**Re: Scone Subdivision Stormwater Management Plan
Response to Northrop Peer Review**

ACOR Stormwater Management Plan (SWMP) for Development Approval was prepared for proposed subdivision at Gundy Road Scone. Revision 1 of the report was issued on 19 August 2021. A peer review of the Stormwater Management Plan was undertaken by Northrop. Refer to Northrop letter titled "*Review of Stormwater Management Plan at 150 Gundy Road, Scone*", and dated 19 January 2022 with a reference number NL213311.

Figure 2. The Strahler System

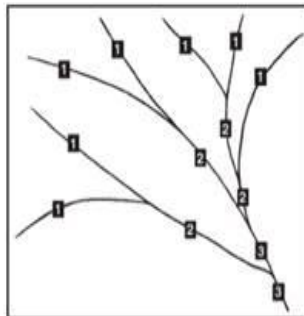
• *Definition of riparian extents should be prepared and placement of Water Quality devices in accordance with NRAR Controlled Activities on Waterfront Land guidelines should be reviewed.*

The riparian extents have been added to the figures in accordance with guidelines for second order stream as detailed below. Refer to Figure 4 and 5.

The stream is Second order and requires 20m riparian buffer either side of formal channel.
